PRASAR BHARTI (BCI)
DIRECTORATE GENERAL: DOORDARSHAN
DOORDARSHAN BHAVAN, COPERNICUS MARG,
NEW DELHI – 110 001.

F.No. 14(4)2010-11/ EI (P) TV.

Subject: Replies/ Amendments to the Specification No:SATD/(4+1&1+1) Digital MCPC CPC July2010 in Tender No. 14(4)2010-11/ EI (P)TV

Subject: Amendment to Specifications SATD/ (4+1 & 1+1) Digital MCPC CPC July 2010 dated 10.08.2010 for SITC of 4+1 & 1+1 Digital MCPC Compression system at CPC New Delhi.

Block Diagram - 3

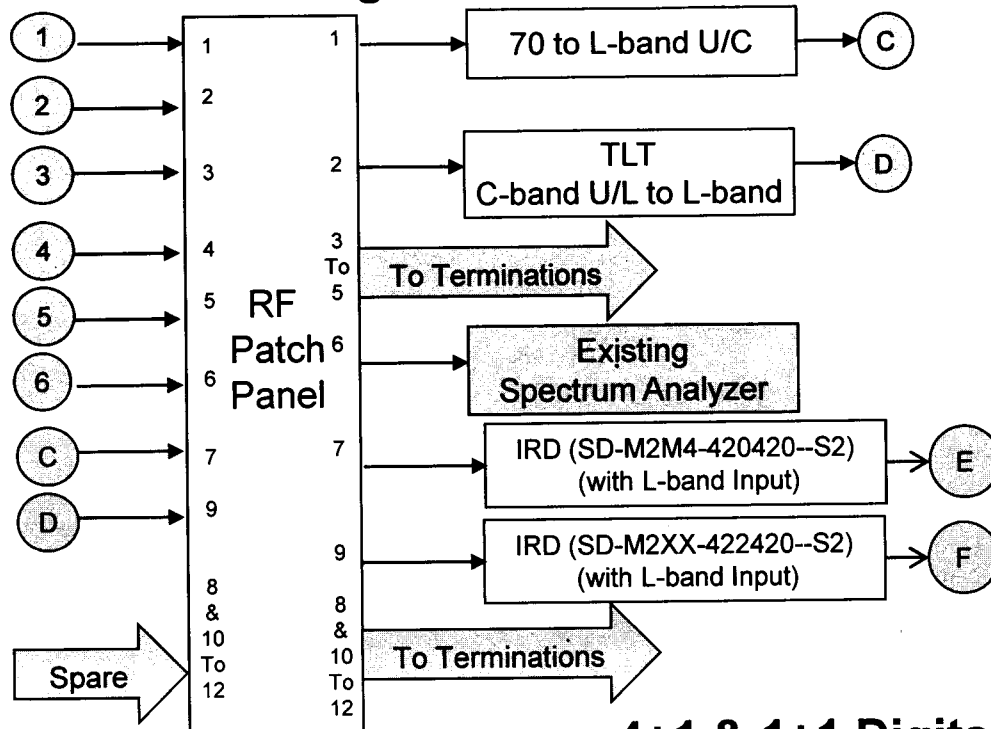
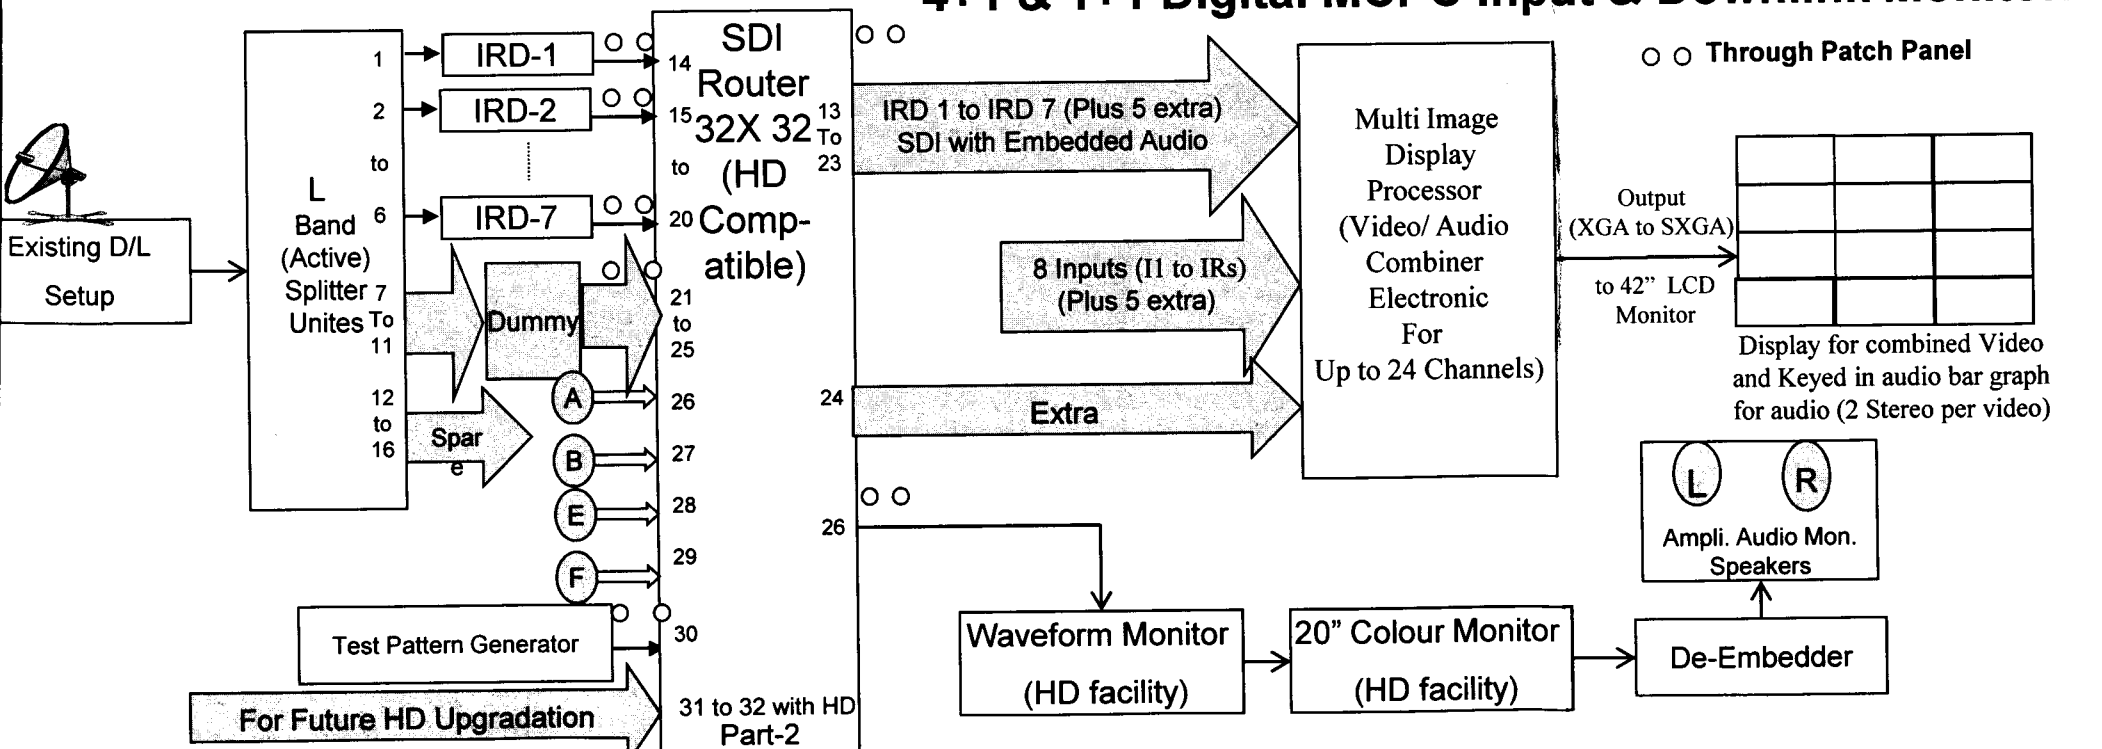
11		Block Diagram-3	DD Specs	Original Block Diagram attached with specifications.	
			Amended as	Revised Block Diagram attached as Annexure -3

Amendment No. - 1 dated 11.10.2010					
Sl. No.	Page No.	Point No.		Description	Ref
1	3	1.1.IV. a)	DD Specs	<p>General Requirements: There should be provision for monitoring points at the following locations: a) SDI with Embedded audio output from optical receiver unit using multi image display processor (for 32 channel Video & Audio combiner) and 42" LCD monitor (Refer block diagram 1 & 3).</p>	
			Amended as	<p>General Requirements: There should be provision for monitoring points at the following locations: a) SDI with Embedded audio output from optical receiver unit using multi image display processor (for display up to 24 channel Video & Audio combiner, presently configured for 16 SD-SDI inputs) and 42" LCD monitor (Refer block diagram 1 & 3).</p>	
2	3	1.1.IV. b)	DD Specs	<p>General Requirements: There should be provision for monitoring points at the following locations: b) SDI with Embedded audio output from professional IRDs using SDI routers and multi image display processor (for display up to 32 channel Video & Audio combiner presently configured for 16 SD-SDI inputs and 8 HD-SDI inputs) and 42" LCD monitor (Refer block diagram 3).</p>

Amended as	<p>General Requirements: There should be provision for monitoring points at the following locations: b) SDI with Embedded audio output from professional IRDs using SDI routers and multi image display processor (for display up to 24 channel Video & Audio combiner, presently configured for 16 SD-SDI inputs) and 42" LCD monitor (Refer block diagram 3).</p>	
3	6	2	DD Specs	<p>SPECIFICATIONS FOR INPUT & BASE BAND SYSTEM Input & base band system consist of OFC link from MSR/ Feed room to Earth Station, which includes Video & Audio Input & Processing Unit, Single Channel Optical transmitter, OFC cable, Single Channel Optical receiver, and Video & Audio Processing & Distribution unit. The units shown in the block diagram may be a single module or it may combination of 3 or 6 modules. (3 nos. of Dual channel module may be offered in place of 6 nos. of single channel optical transmitter). A complete system to house these modules and power supply units should be included in the offer. The Chassis to be used for housing the Embedder, Optical transmitter and Optical receiver should have provision for inserting additional cards for HD signal processing.</p>
